PHASE 2. HISTORIC STRUCTURES/SITES LETTER REPORT

256 Eucalyptus Hill Road
Santa Barbara, California
(APN 015-050-026)

This Phase 2 Historic Structures/Sites Letter Report assesses revised plan sets for alterations to the property at 256 Eucalyptus Hill Road (APN 015-050-026). The applicant proposes revisions to the previously reviewed plans for the house and grounds (Figures 1 – 3). The property was designated a City of Santa Barbara Structure of Merit on March 17, 1999. Previous renovations of the property were the focus of a Phase I-II Historic Resources Report prepared by Post/Hazeltine Associates dated December 28, 1999. A subsequent Phase 2 Historic Structures/Sites Letter Report dated October 13, 2021, evaluated proposed alterations to the main residence and grounds.

Figure 1, Partial floor plan identifying the location of proposed alterations (Sheet A-2.1)

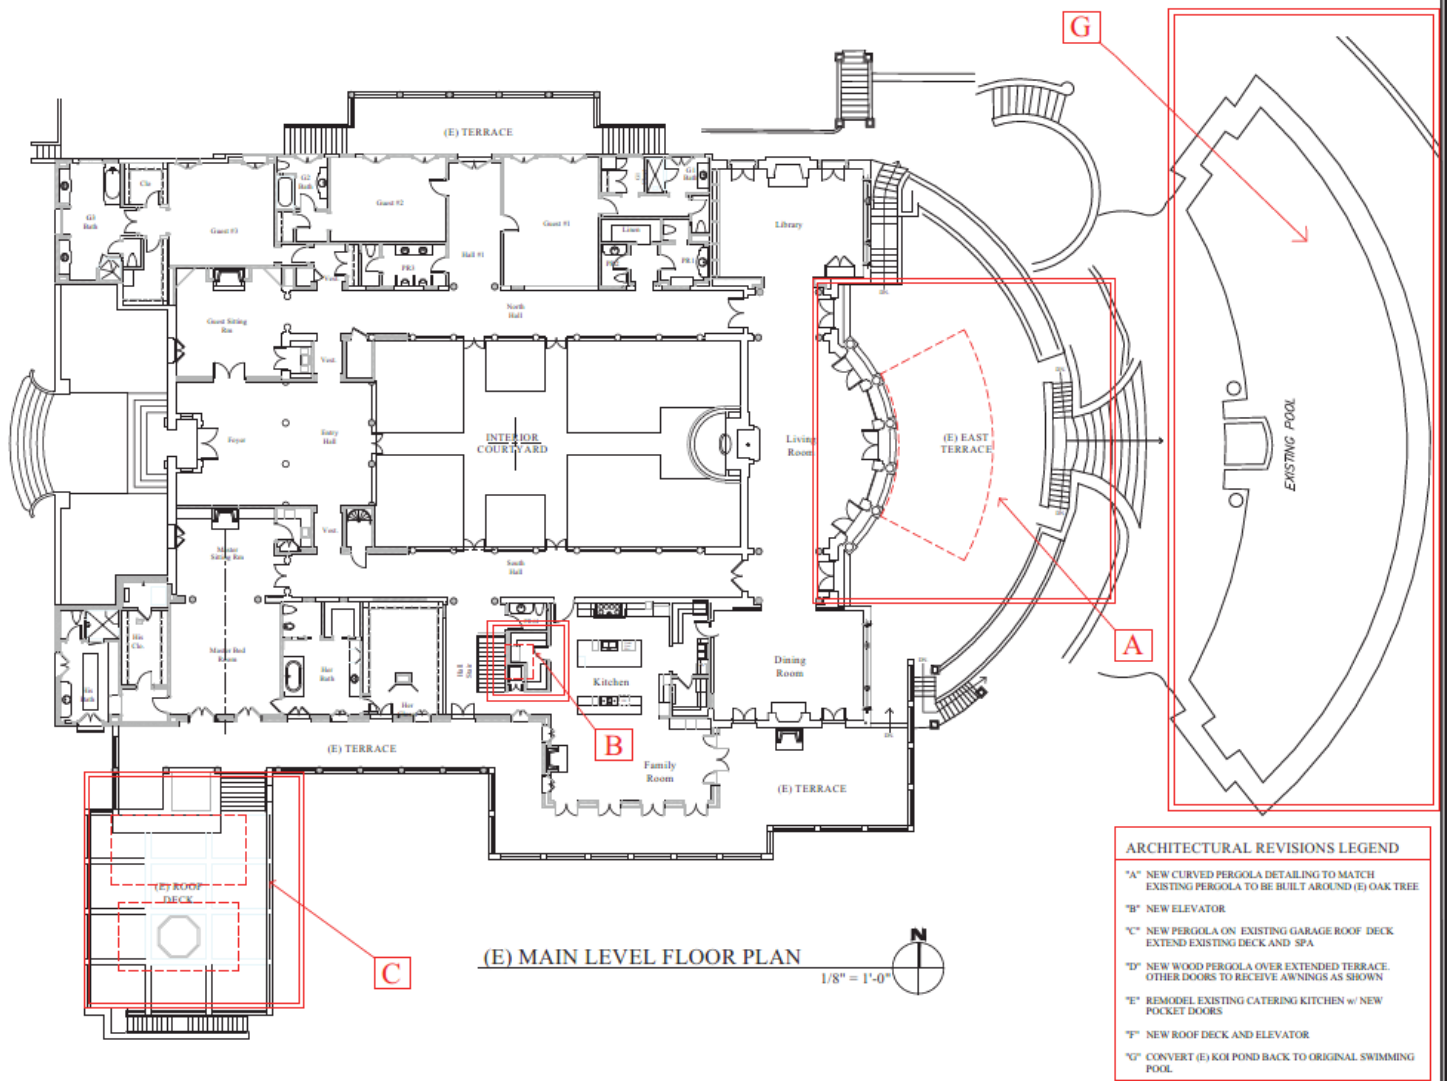
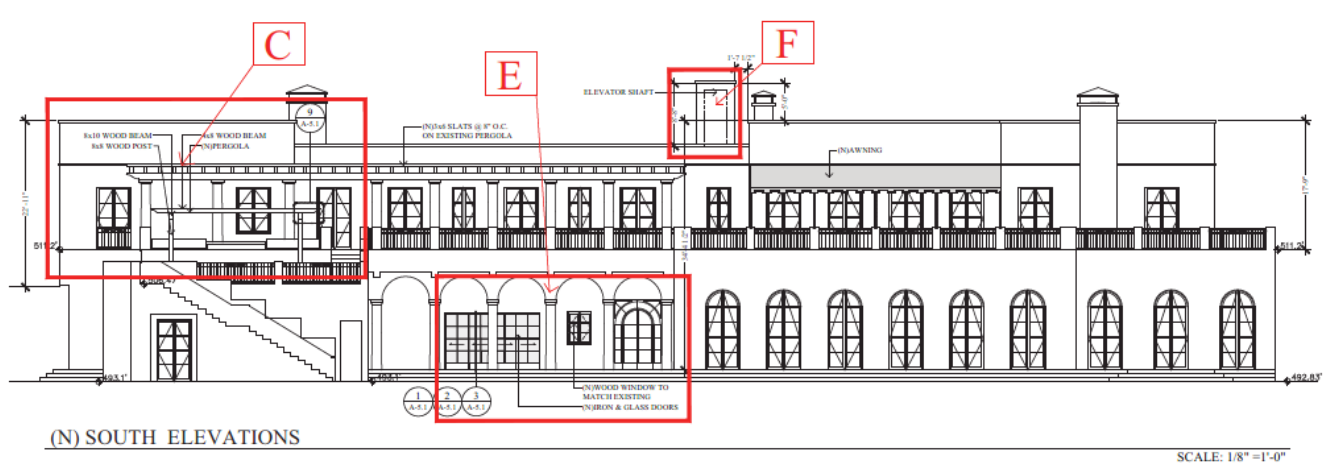
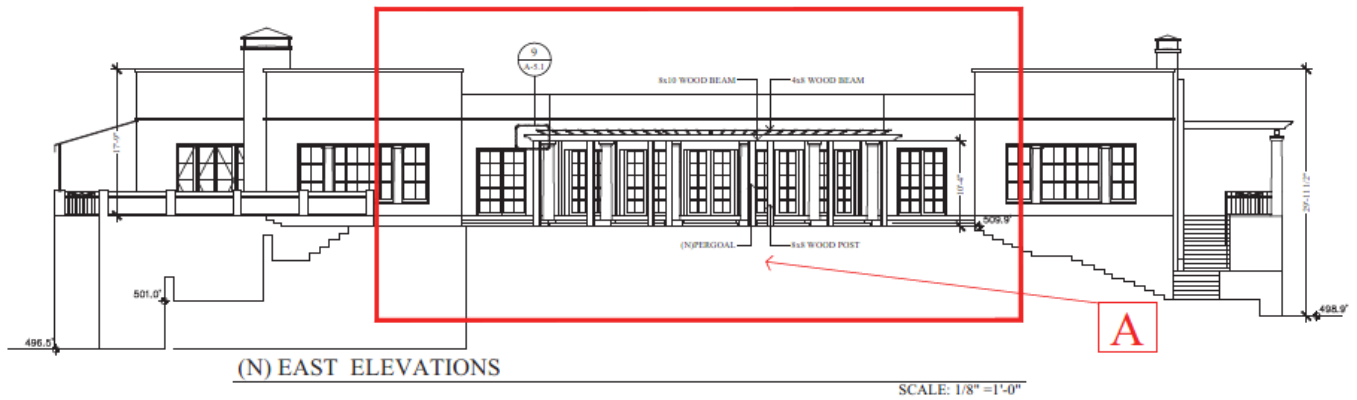
A. The design of the proposed freestanding pergola off the west end of the house has been refined to avoid a sizeable native oak tree. The pergola would emulate an existing wood pergola on the house's south elevation in materials, proportions, and style. Moreover, the design of the pergola and its placement are consistent with the scheme evaluated in the 2021 letter report, which met the Secretary of the Interior's Standards for Rehabilitation. Therefore, the implementation of the proposed scheme would not impair the resource.

B. The design of the proposed elevator matches the earlier scheme. It would feature plastered walls and reductive architectural detailing. Moreover, the design of the elevator

and its placement are consistent with the scheme evaluated in the 2021 letter report, which met the Secretary of the Interior's Standards for Rehabilitation. Therefore, implementation of the proposed design for the elevator would not impair the resource.

C. Alterations to the rooftop of the existing garage wing, which include a new pergola and surfacing materials, have been further refined. The pergola would emulate an existing wood pergola on the house's south elevation in materials, proportions, and style. Moreover, the design of the pergola and its placement are consistent with the scheme evaluated in the 2021 letter report, which met the Secretary of the Interior's Standards for Rehabilitation. Therefore, implementation of the proposed scheme for a rooftop deck and pergola would not impair the resource.

1. Alter non-historic fenestration on the south elevation's ground floor by adding two glazed French doors, and a multi-light metal window would be added. The existing fenestration is not original. The proposed replacement fenestration matches the existing fenestration in design and materials. Moreover, the design of the two doors and a window is consistent with the scheme evaluated in the 2021 letter report, which met the Secretary of the Interior's Standards for Rehabilitation. Therefore, implementation of the proposed scheme for altering the south elevation's existing fenestration would not impair the resource.

Figure 1c, West Elevation, location of the new entrance doors (Item D) on the west elevation (Sheet A-3.1)

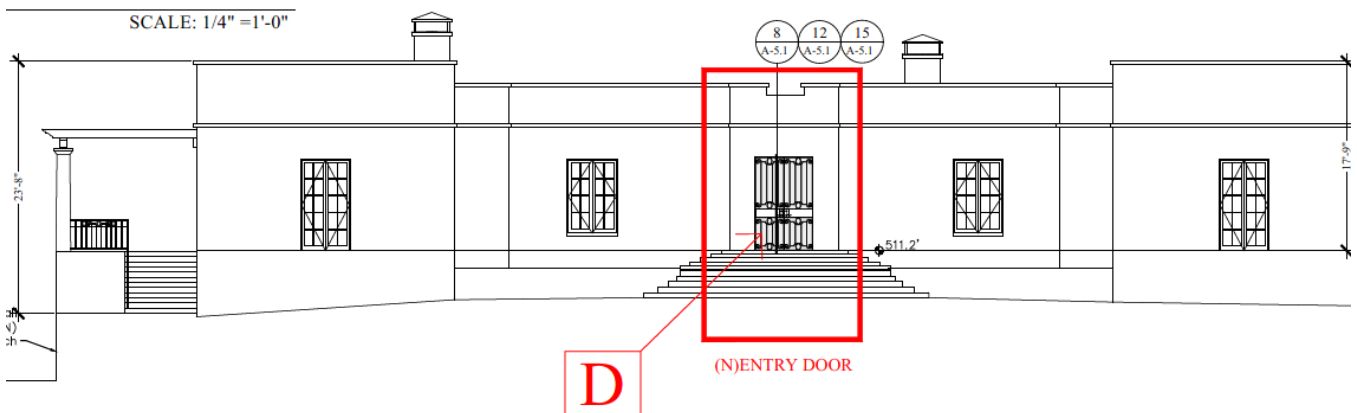
D. Replace the existing non-historic glazed metal front doors on the west elevation with a new set of glazed metal doors. The new doors emulate the existing doors in overall design and materials. Replacement of the non-historic glazed doors with a new set of doors designed to emulate design features of early 20th century doors would not remove design features or materials that contribute to the building's historic or architectural significance. Therefore, replacing the existing non-historic doors would not impair the resource.

Figure 3, Proposed design for a gate and pergola for the guesthouse (Sheet A-3.1)

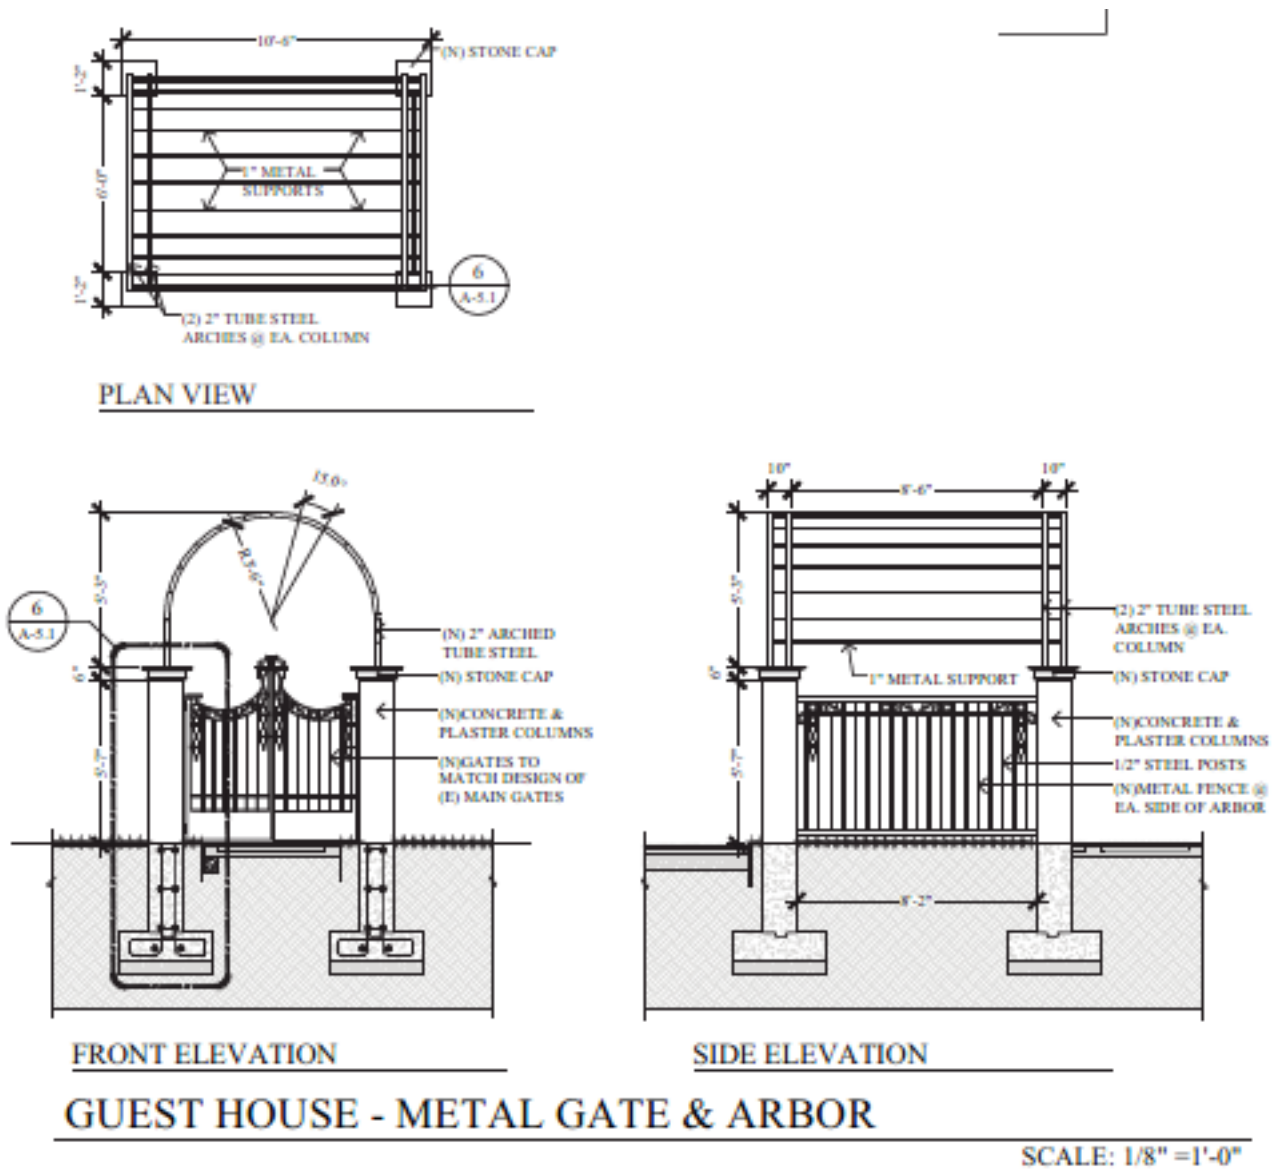
1. Add a detached metal gated and pergola to the guesthouse's exterior. The design of the pergola and gate are consistent with hardscape features added in 1999 and emulate the motifs characteristic of early 20th century pergolas and gates. Therefore, implementation of the proposed scheme for altering the pergola and gate would not impair the resource.
2. Add paving off the east side of the guesthouse, which is level with the motor court.

The proposed design and materials for a paved entry off the guesthouse's east elevation would not introduce materials or design features out of character with the existing landscaping. Therefore, implementation of the proposed scheme added paving would not impair the resource.

Figure 4, Site plan for alterations to the hardscape (L 1.00)

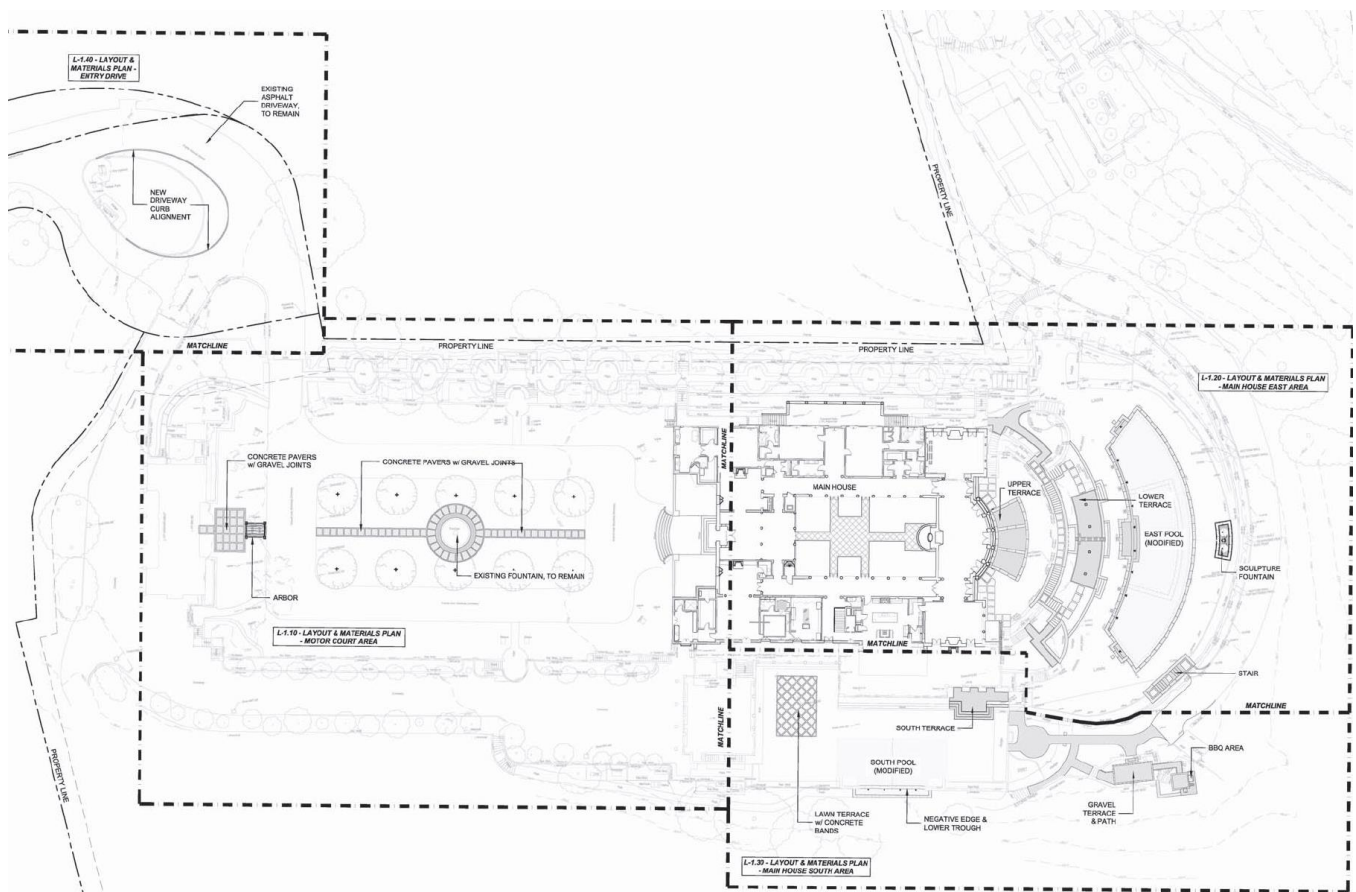
- All proposed 'HydroFlo Permeable Pavers' have been omitted for aesthetic reasons; and
- Proposed paving at upper terrace has been changed to terracotta pavers to match those existing on site, with a stone border;
- Paving at lower lounge terrace has been changed to terracotta pavers to match those existing on site, with a stone border;
- Footprint of lower lounge terrace has been reduced;
- Paths and landings have been changed to pavers with planted or gravel joints to achieve permeability;
- Stairs from the lower lounge terrace to the lawn have been reoriented and reduced per updated layout; and
- New pool floor for East Swimming Pool to achieve level shallow and deep ends and gradual pitch.

- Small terrace east of the garage has been removed and existing path is to remain;
- Removal of concrete planter base west of Recreation Room;
- Proposed terrace and pergola south of the Recreation Room has been omitted. Existing stairs to remain;
- Addition of small terrace south of His Study to integrate into existing stairs. Material will be terra cotta pavers to match those existing on site, with a stone border and concrete stairs to match existing; and

- Dining Terrace footprint has been reduced to maintain layout of existing south-facing wall where adjacent native oaks, to ensure health and maintenance of protected trees.

1. Design details for the surfacing materials, including brick, concrete, terra cotta pavers, and gravel, have been finalized. The proposed materials are consistent with the materials approved for the 1999 project and would not introduce materials or design features out of character with the house or its setting. Moreover, the proposed materials are consistent with the scheme evaluated in the 2021 letter report, which met the Secretary of the Interior's Standards for Rehabilitation. Therefore, installing the proposed landscaping materials would not impair the resource.

2. The design of the motor court's hardscape and plantings has been finalized. Proposed materials such as stone pavers and concrete are consistent with the main residence's original construction materials and the landscape and hardscape features added during the 1999 renovation. Moreover, refinements to the design of the motor court are consistent with the scheme evaluated in the 2021 letter report, which met the Secretary of the Interior's Standards for Rehabilitation. Therefore, implementation of the proposed scheme for the motor court would not impair the resource.

3. Refinements to the design of the south terrace, barbeque area, terraces, steps, and pathways are consistent in materials and design, with the original main residence and hardscape and the 1999 remodeling project. Moreover, refinements to the design barbeque area and its setting are consistent with the scheme evaluated in the 2021 letter report, which met the Secretary of the Interior's Standards for Rehabilitation. Therefore, implementation of the plan for this area of the property would not impair the resource.
